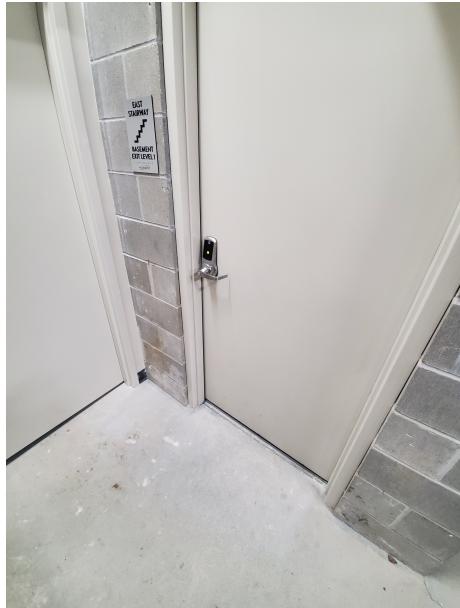
- Caulking not completed around balcony brackets

- Sheet metal not covering building wrap in certain locations

- All the stair doors in the basement need to be unlocked at all times for emergency egress reasons.

- Trim end not finished in certain areas in stair wells.
